SERVICE PROCEDURE

G-07501-R1
May 2007

**SUBJECT: SAFETY RECALL (U.S., EXPORT)
BATTERY CABLES on certain 9000 Models built
4/1/2002 thru 12/25/2006 with Caterpillar® Engines**

REVISION DESCRIPTION

Figure 6

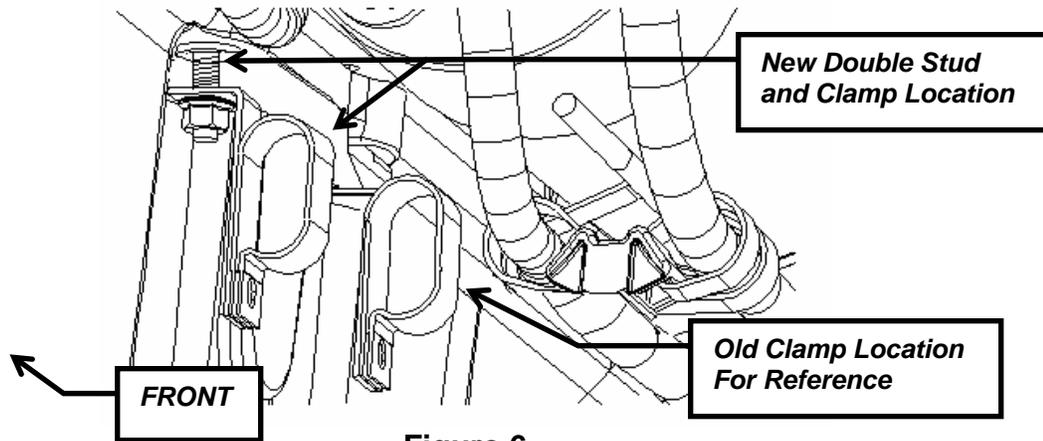
11. Remove oil pan bolt and replace with second new double stud bolt. Torque second new double stud bolt to **33-48 LbF-Ft (45-65Nm)**. – Do not install L-bracket on new double stud at this time.

NOTE: For C10/12, install washer/spacer between oil pan and existing stud spacers. Ensure stud is not bottoming out against block before moving on to step 12.
